UNITED STATES PATENT AND TRADEMARK OFFICE

APPLICATION NO.	FILING DATE	FIRST NAMED INVENTOR	ATTORNEY DOCKET NO.	CONFIRMATION NO.
10/669,800	09/25/2003	Hiroyuki Kato	A-9925	5437
181 75	590 06/30/2004		EXAMINER	
MILES & STOCKBRIDGE PC			MITCHELL, KATHERINE W	
1751 PINNACI SUITE 500	LE DRIVE		ART UNIT	PAPER NUMBER
MCLEAN, VA	22102-3833		3677	
			DATE MAIL ED. 06/20/2004

-l.
	Application No.	Applicant(s)	
	10/669,800	KATO, HIROYUKI	7
Office Action Summary	Examiner	Art Unit	
	Katherine W Mitchell	3677	
The MAILING DATE of this communication Period for Reply	appears on the cover sheet w	ith the correspondence address	**
A SHORTENED STATUTORY PERIOD FOR RETHE MAILING DATE OF THIS COMMUNICATIO - Extensions of time may be available under the provisions of 37 CFR after SIX (6) MONTHS from the mailing date of this communication. - If the period for reply specified above is less than thirty (30) days, a - If NO period for reply is specified above, the maximum statutory per - Failure to reply within the set or extended period for reply will, by state Any reply received by the Office later than three months after the material patent term adjustment. See 37 CFR 1.704(b).	N. R 1.136(a). In no eve

DETAILS OF FIG. 2 (PARTIALLY INSERTED) AND FIG 5 (FULLY INSERTED) FROM UENO.

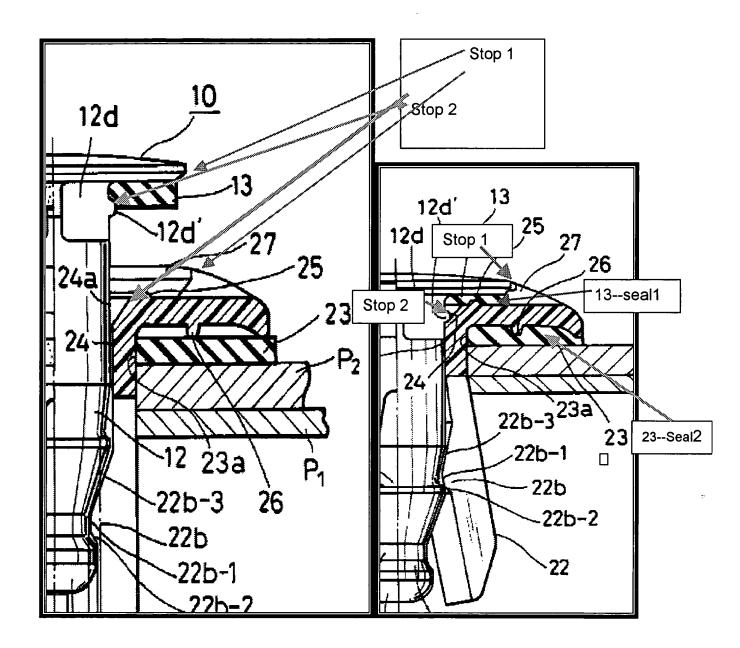
The most relevant labeled sections of Figures 2 and 5 from Ueno are shown below:

Re claim 1: Ueno teaches a clip capable of connecting a member to a body comprising:

- > a pin (10) with a head (11) and a shank (12) extending from the head;
- ➤ a bushing (20) with a flange (21) and a shank (22) extending from the flange, with a through-hole (24) in said flange and bushing shank, and
- ➤ a water tight seal (13) member on the pin shank adjacent to the head and capable of compression between the pin head and the flange. Examiner notes seal (13) is described by Ueno as "elastomeric", which would be inherently water-tight:

Wherein a stop (12d' on the pin head in Figs 2 and 5 or angled outer circumferential edge of pin head best shown as touching lead line "11" in Fig 1A) is formed on at least the pin head or the flange to keep a predetermined compressed thickness of the seal member (13) when pin shank (12) is inserted into through hole (24) and presses the seal member between pin head (11) and flange (21) (see Fig 2 - how 12d' fits in 24a and causes the downward movement to stop, and how the raised unshaded wedge near "27" has an angled edge that engages the outer circumferential edge angled projection of pin head 11 (with or

without projections (t)), thus also limiting compression to a predetermined amount. (Shown uncompressed in Fig 2 and compressed in Fig 5).

- wherein the pin head (11) is a circular plate (Fig 1) with a diameter smaller than diameter of bushing flange (21) (see Fig 2 ---11's diameter is clearly smaller than 21's diameter).
- > The stop (12d' or pin outer circumferential edge angled projection) comprises

edge directly under 24a) of the bushing flange and is disposed to engage the stop plate portions when the seal member is compressed (Figs 1B, 2, and 8 - examiner has shown a blow up of Fig 2 with outer wall 24a /outer edge;)
Similarly, unshaded wedge near "27" comprises an outer wall formed on an outer edge of the bushing flange (see box detail above) and is disposed to engage the stop plate portions comprising the outer circumferential edge angled projection of the pin head (11) (pin head edge shown only in complete Fig 2 and 5, not in detail above) and the height of the outer wall is predetermined to provide a predetermined compressed thickness of the seal member (as the

the flange has a recess (the inner flat part of flange, extending from aperture to raised lip best indicated as unshaded wedge member near "27") surrounded by outer wall for receiving the seal member. (Seal member 13 is best shown in Fig 5 fitting in said recess formed on top surface of flange 21)

▶ pin shank (12) and bushing shank (22) have cooperable parts that connect the shanks in a non-expanded-diameter-connection position in which the bushing is not expanded when the pin shank is inserted partially into the bushing shank (Fig 2 - note that pin shank is partially inserted and bushing shank is not expanded).

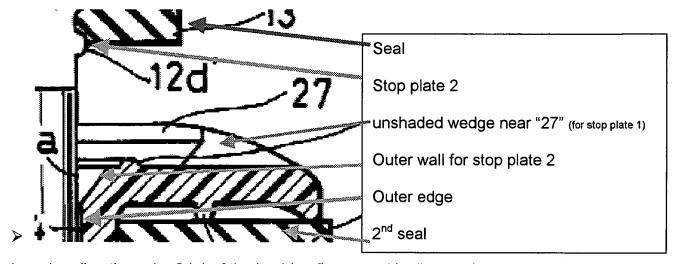
While in the above-described configuration the doughnut-shaped resilient seal 13 disposed in contact with the side of the head 11 on which the shaft 12 is located is held in place by projections 12d' on the fins 12d, an alternative arrangement may be used such as the one shown in FIG. 7 in which the seal 13 is kept in position by appropriate projections t around the edge of the head 11.

The projections (t) around the edge also inherently serve as stops to prevent overcompression of the seal.
